Amendments to the Drawings:

The attached sheets of drawings include changes to **Figures 1A, 2A, 3A, 5, 6A, 7A, 8, 12 and 17A.**

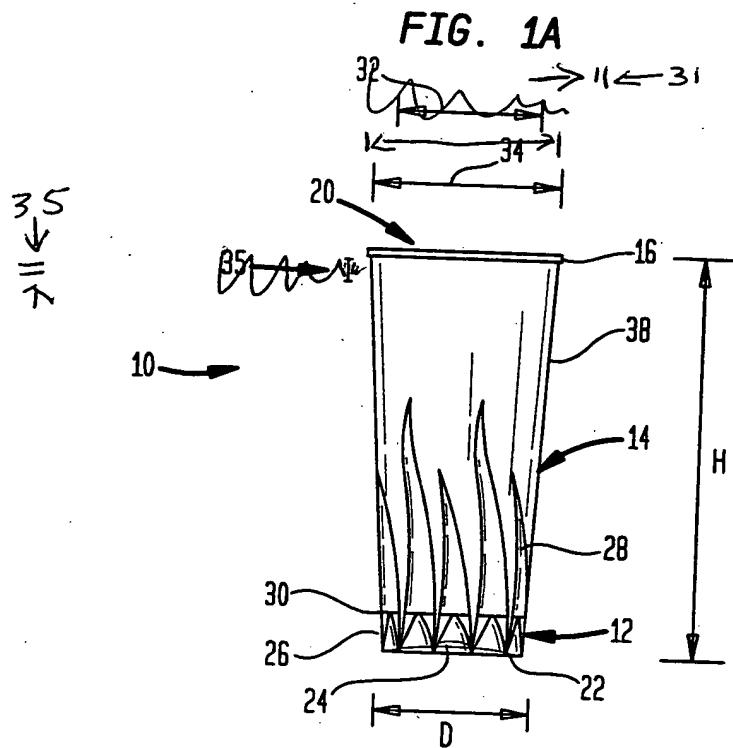
On **Figure 1A**, it is proposed to show inner diameter **32** more accurately as well as height **35** and width **31** of the rim. These proposed changes conform the drawing better to the text at p. 21, lines 4-26:

Tumbler **10** is optionally provided with a molded-in design **28** which is more clearly seen by reference to **Figures 1(b) and 1(c)**. Base sidewall **26** extends upwardly to define an outer edge **30** which attaches to sidewall **14**. Sidewall **14** extends upwardly to form a rim **16**. Rim **16** is integrally formed with sidewall **14** and is a continuous generally circular or oval, solid polymer bead extending about periphery **18** of opening **20**. Rim **16** has a width **31** which is defined by the difference between an inner diameter **32** and an outer diameter **34** of rim **16** and a height **35** which is the distance over which width **31** extends. Width **31** is thicker than adjacent sidewall portion **38** which is typically of the same caliper as the rest of sidewall **14**. In the example shown in **Figures 1(a) – 1(c)**, adjacent sidewall portion **38** has a thickness of 10 mils, height **35** is approximately 28 mils and width **31** is approximately 40 mils at its thickest point.

Other dimensions of tumbler **10** are indicated on **Figure 1A**. Base portion **12** has a diameter **D**, at edge **30** of about 2.125 inches, an outer upper diameter **34** of 2.770 inches and an inner upper diameter **32** of 2.730 inches. The overall height, **H**, of tumbler **10** is 5.785 inches. These dimensions define an angle of taper **T** as shown about imaginary central axis **40** of about 3° for sidewall **14** of tumbler **10**. As used herein “taper”, “degree of taper” and like terminology indicates the angle that the sidewall of the inventive tumbler makes with the imaginary central longitudinal axis defined by the sidewall which is substantially perpendicular to bottom **22**, the taper of the article may also be thought of as the angle the sidewall makes with the bottom less 90 degrees.

FIG. 2A

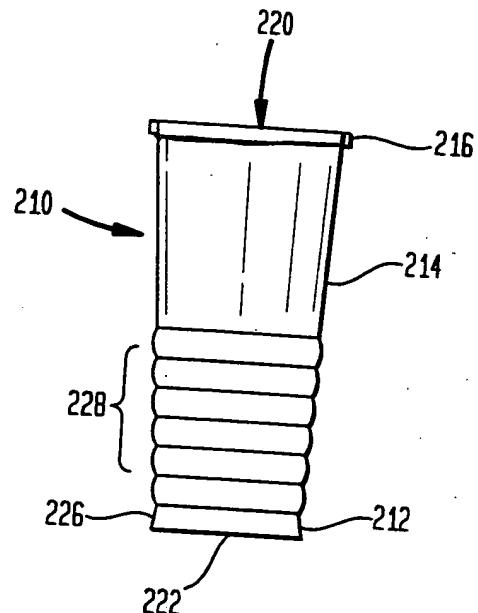
The rim on **Figure 2A** should look like the rim on the tumbler of **Figure 1**. This change is consistent with **Figure 1** and the text as filed on p. 22, lines 8-20:

There is shown in **Figures 2(a) and 2(b)** another tumbler **210** constructed in accordance with the present invention. In general, tumbler **210** has a base portion **212**, a sidewall portion **214** and an upper circular fortified rim portion **216** which extends about the periphery **218** of an opening **220** of tumbler **210**. Base portion **212** of tumbler **210** is integrally formed with the rest of the tumbler and includes a bottom **222** which has a meniscus portion

FIG. 3A

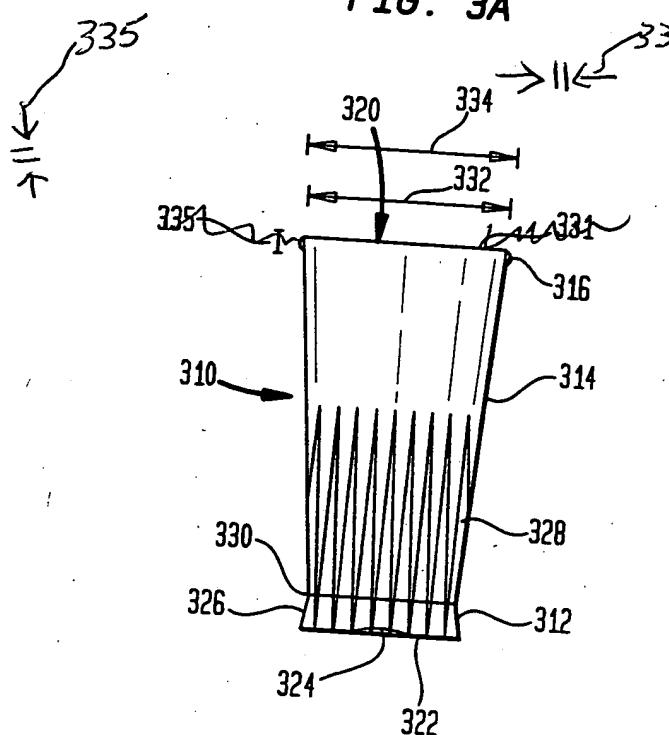
On **Figure 3A**, thickness **331** and height **335** of the rim should be shown as on **Figure 1**. Also, the rim should be shown as in **Figures 1** and **2**. These changes are supported by the specification as filed at p. 23, lines 8-20:

Base sidewall **326** extends upwardly to define an outer edge **330** which attaches to sidewall **314**. Sidewall **314** extends upwardly to fortified rim **316**. Rim **316** is integrally formed with sidewall **314** and is a continuous generally circular or oval, solid polymer bead extending about periphery **318** of opening **320**. Rim **316** has a width **331** which is defined by the difference between an inner diameter **332** and an outer diameter **334** of rim **316** and a height **335** which is the longitudinal distance over which width **331** extends. Width **331** is thicker than adjacent sidewall portion **338** which is typically of the same caliper as the rest of sidewall **314**. In the example shown, adjacent sidewall portion **338** has a thickness of 20 mils height **335** is approximately 28 mils and width **331** is approximately 40 mils at its thickest point. Other dimensions of tumbler **310** are approximately identical to those of tumblers **210** of **Figures 2(a)** and **2(b)** and tumbler **10** of **Figures 1(a) – 1(c)**. Tumbler **310** thus has a taper of 3°.

FIG. 5

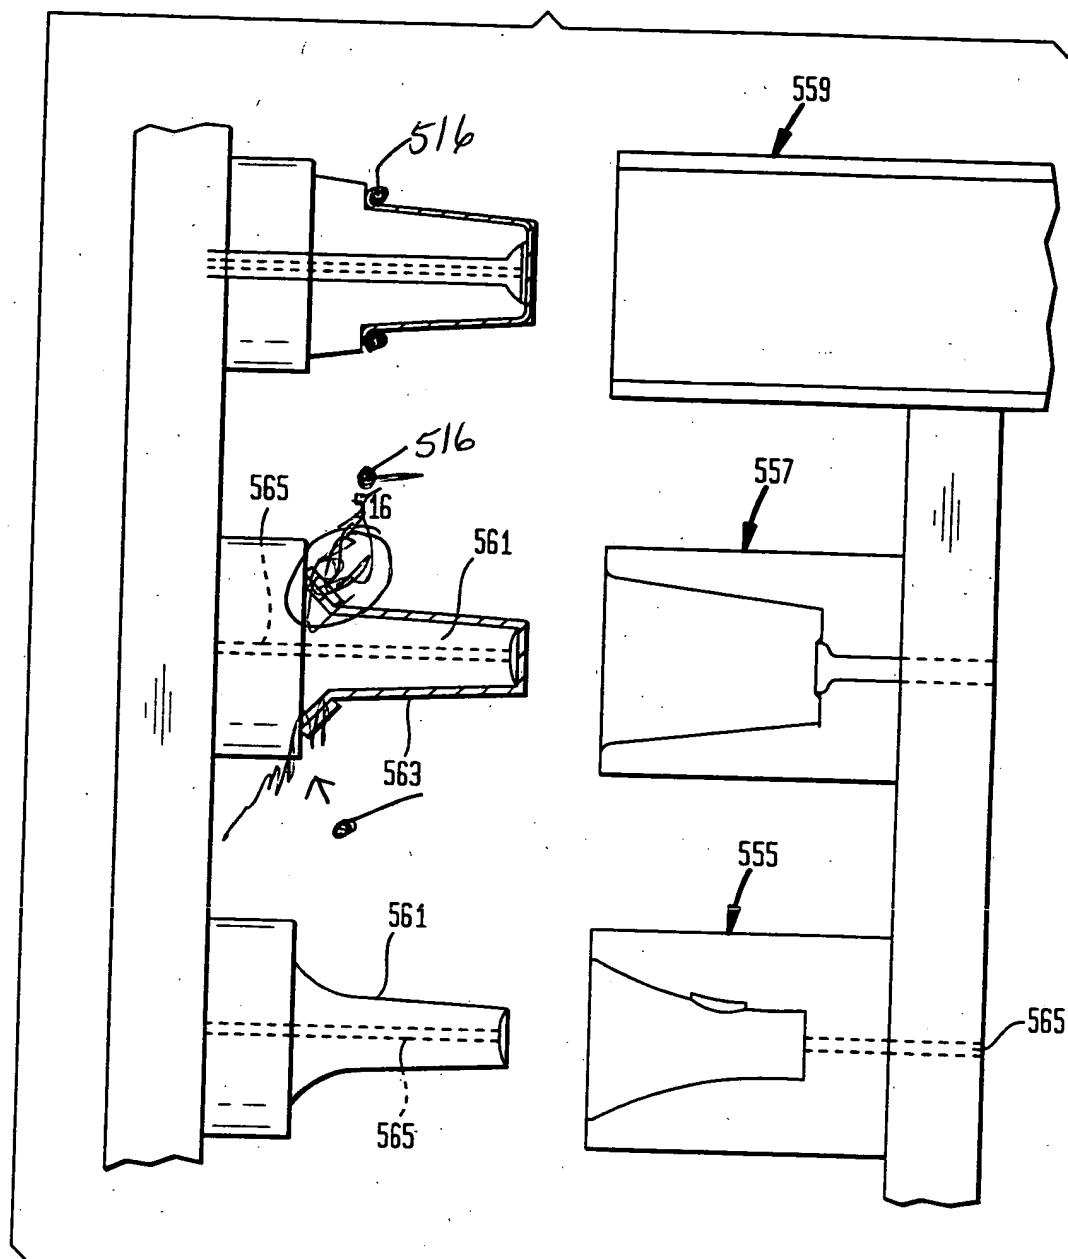
The fortified rim **516**, **Figure 5**, should appear schematically the same as in **Figures 4A, 4B**.

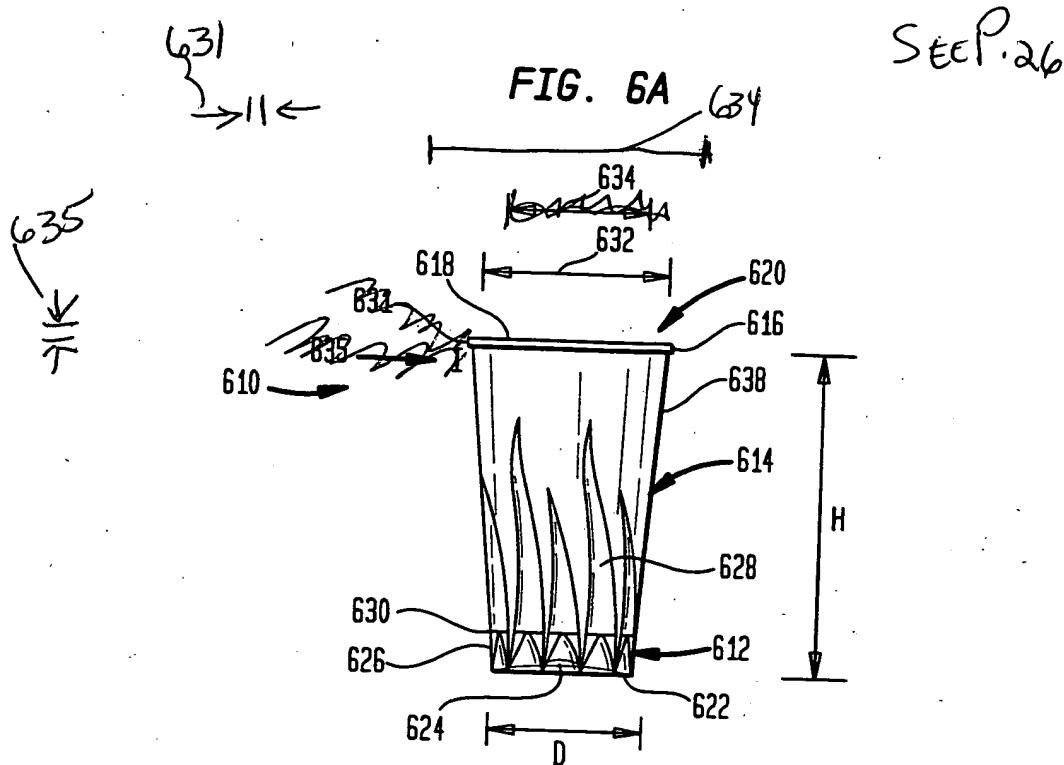
In **Figure 6A**, the diameters, widths and so forth should conform to the text at p. 26, lines 8-18:

Base sidewall **626** extends upwardly to define an outer edge **630** which attached to sidewall **614**. Sidewall **614** extends upwardly to fortified rim **616**. Rim **616** is integrally formed with sidewall **614** and is a continuous generally circular or oval, solid polymer bead extending about periphery **618** of opening **620**. Rim **616** has a width **631** which is defined by the difference between an inner diameter **632** and an outer diameter **634** of rim **616** and a height **635** which is the distance over which width **631** extends. Width **631** is thicker than adjacent sidewall portion **638** which is typically of the same caliper as the rest of sidewall **614**, that is, sidewall **614** is substantially uniform in thickness on

the entire tumbler. In the example shown, adjacent sidewall portion 638 has a thickness of 20 mils, height 635 is approximately 28 mils and width 631 of rim 616 is approximately 40 mils at its thickest point.

FIG. 7A

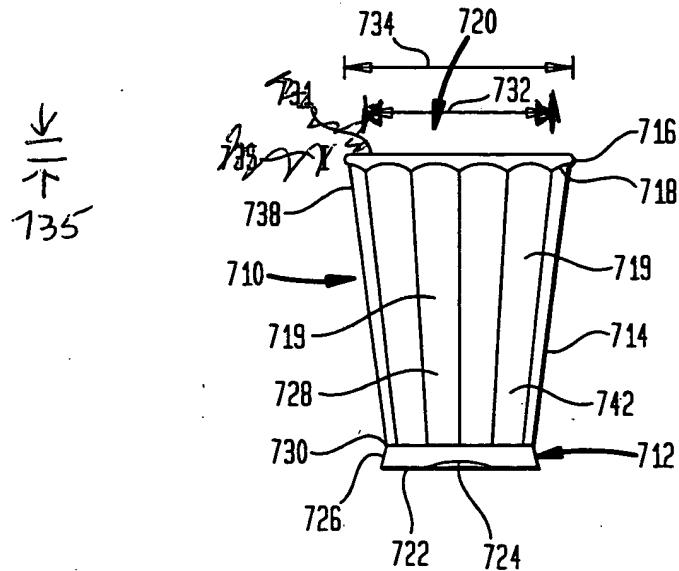
Figure 7A should be conformed to **Figures 1A, 2A, 3A and 6A**. These changes conform the **Figure** to the text at the bottom of page 27 and top of page 28:

Rim 716 is integrally formed with sidewall 714 and is a continuous generally circular or oval, solid polymer bead extending about periphery 718 of opening 720. Rim 716 has a width 731 which is defined by the difference between an inner diameter 732 and an outer diameter 734 of rim 716 and a height 735 which is the distance over which width 731 extends. Width 731 is thicker than adjacent sidewall portion 738 which is typically of the same caliper as the rest of sidewall 714. In the example shown, adjacent sidewall portion 738 has a thickness of 20 mils, height 736 is approximately 28 mils and width 731 is approximately 40 mils at its thickest point.

FIG. 8

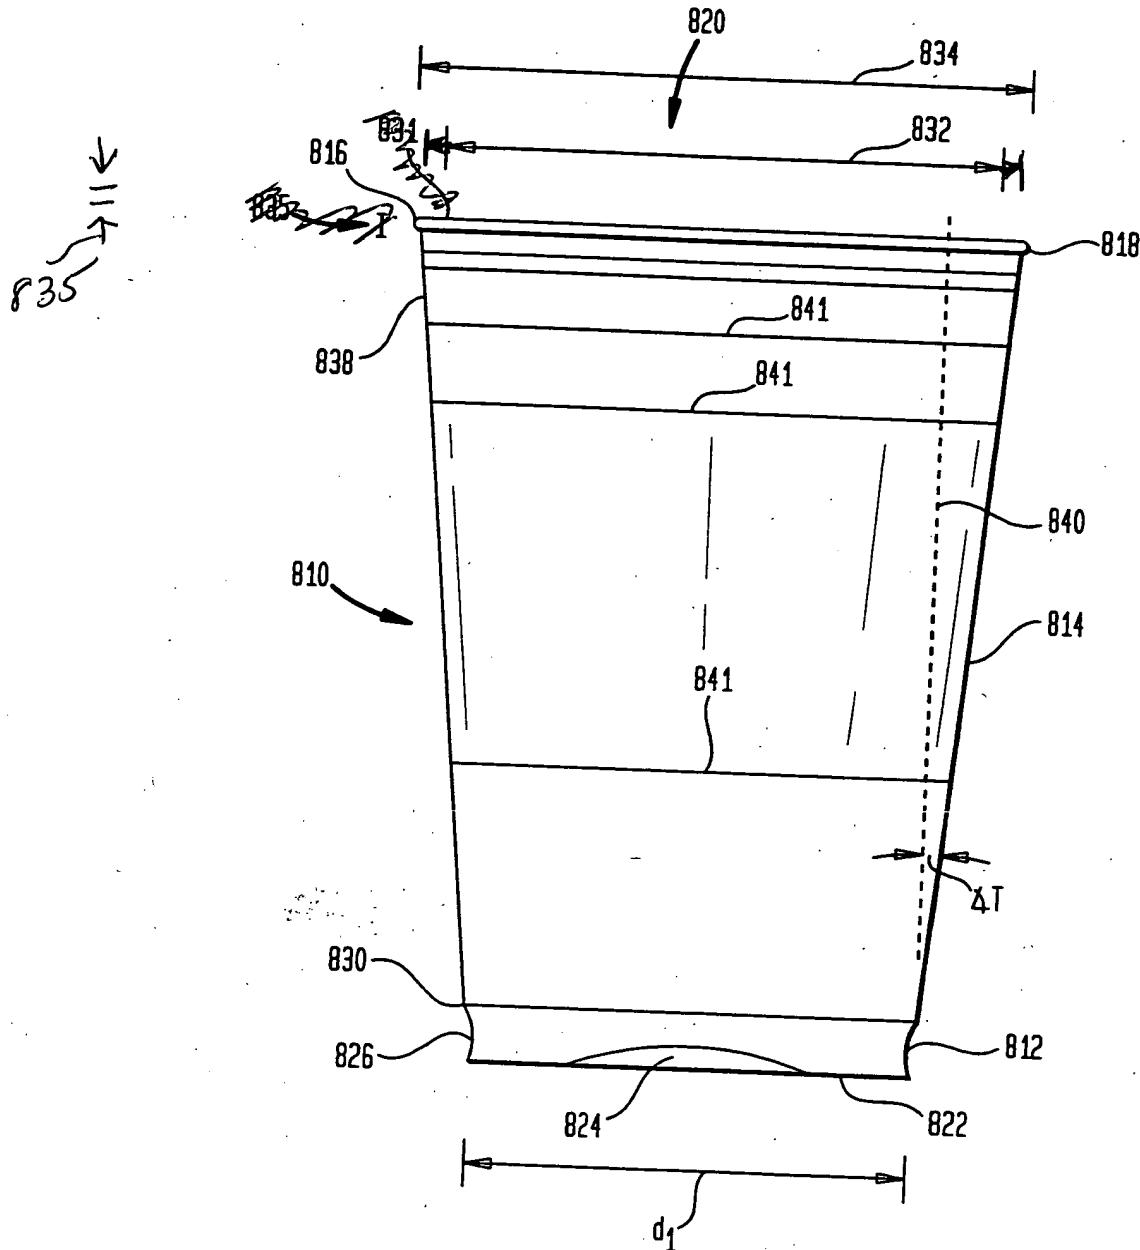
Figure 8 should be consistent with the other tumblers and text at page 29, beginning on line 10:

Base sidewall 826 extends upwardly to define an outer edge 830 which attaches to sidewall 814. Sidewall 814 extends upwardly to fortified rim 816. Rim 816 is integrally formed with sidewall 814 and is a continuous generally circular or oval, solid polymer bead extending about periphery 818 of opening 820. Rim 816 has a width 831 which is defined by the difference between an inner diameter 832 and an outer diameter 834 of rim 816 and a height 835 which is the distance over which width 831 extends. Width 831 is thicker than adjacent sidewall portion 838 which is typically of the same caliper as the rest of sidewall 814, that is, sidewall 814 is substantially uniform in thickness on the entire tumbler. In the example shown, adjacent sidewall portion 838 has a thickness of 20 mils, height 835 is approximately 28 mils and width 831 of rim 816 is approximately 28 mils and width 831 of rim 816 is approximately 40 mils at its thickest point. The tumbler is also provided with a series of molded-in grooves 841 which extend around the tumbler. These grooves

provide a grip for a user as well as providing rigidity to the article. Typically, the circumferential grooves 841 have a depth of from 810 to 40 mils.

FIG. 12

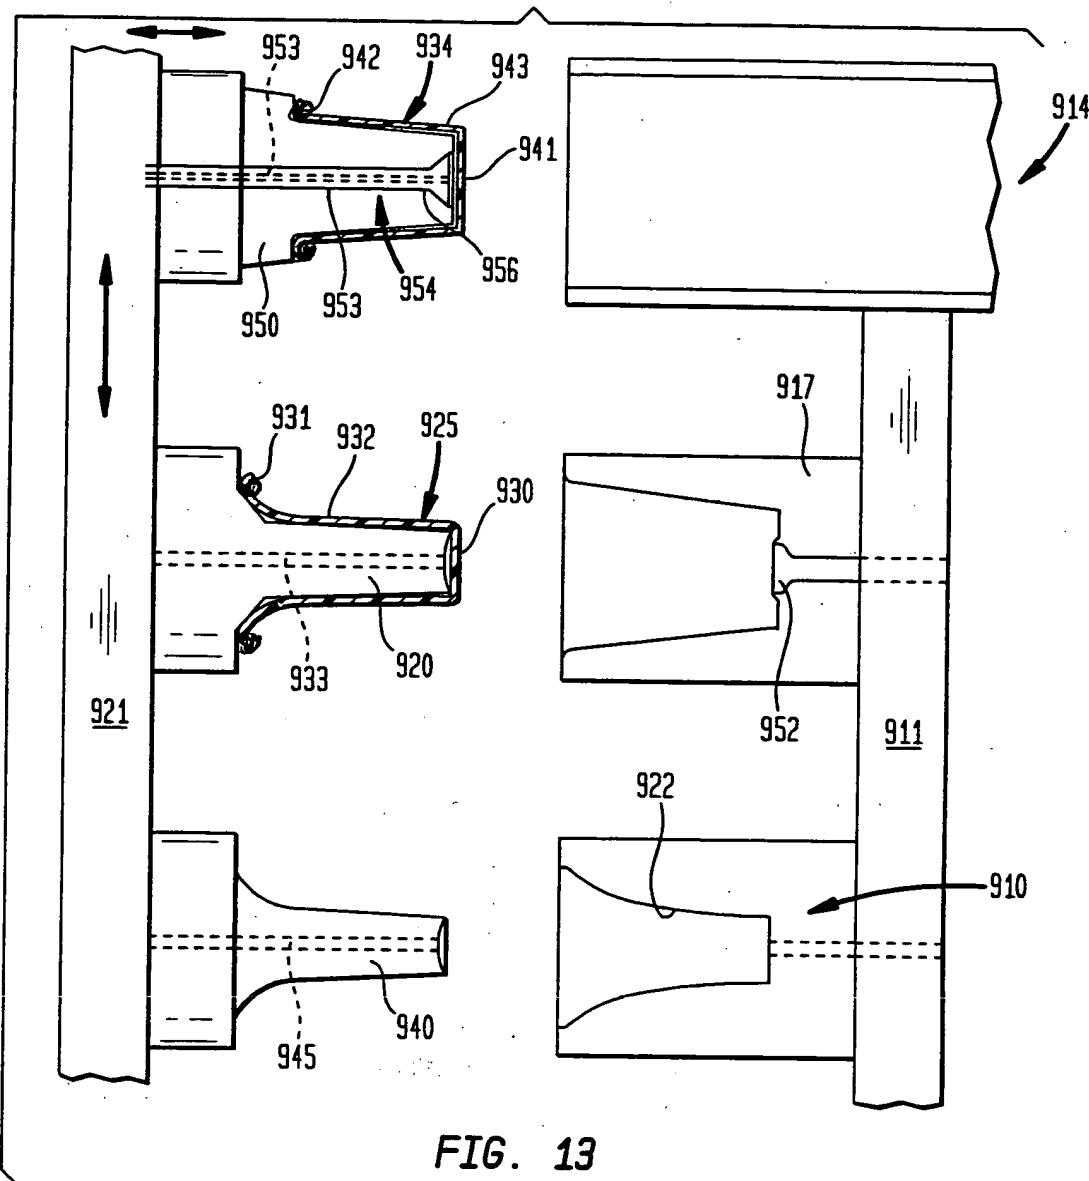
On Figure 12, fortified rims 931, 942 should be conformed schematically to look like Figure 4B. See pages 34, 36 of the application as filed.

FIG. 17A

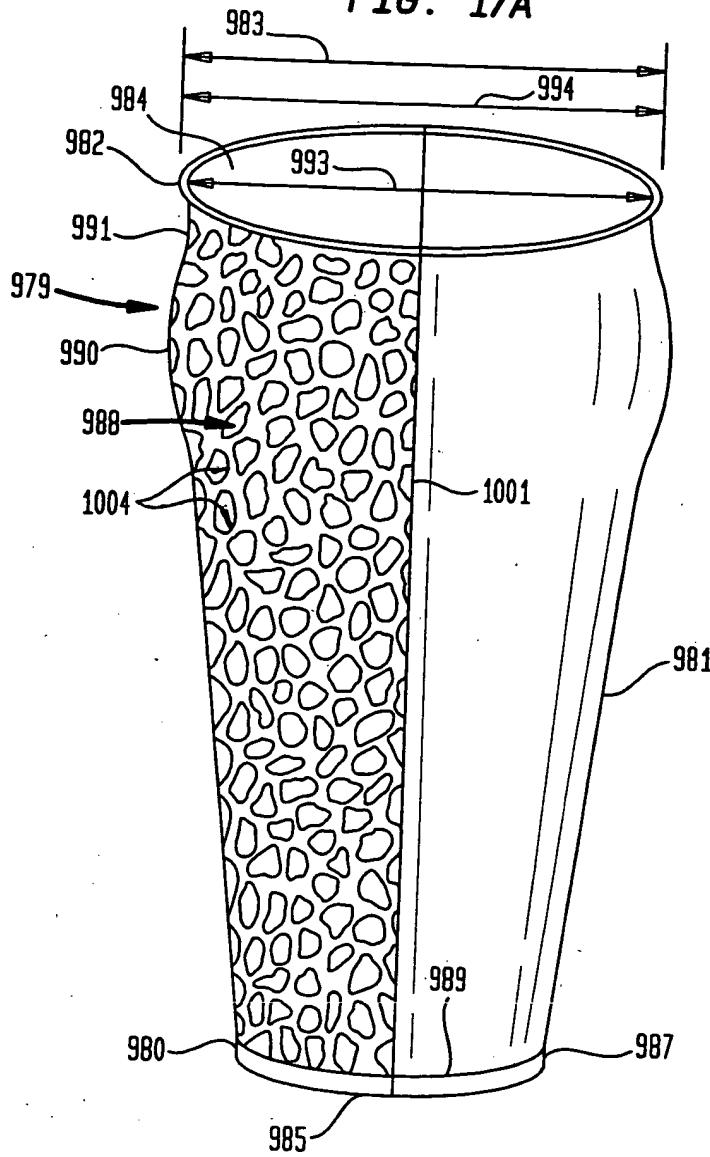
Finally, on **Figure 17A**, lines **1004** should extend to the edge of the embossed area as noted on p. 44, lines 5-7:

For example, tumbler 979 can optionally be provided with an embossing design defined by embossed flat surfaces 988 and ridges 1004 which circumscribe the embossed areas 988.
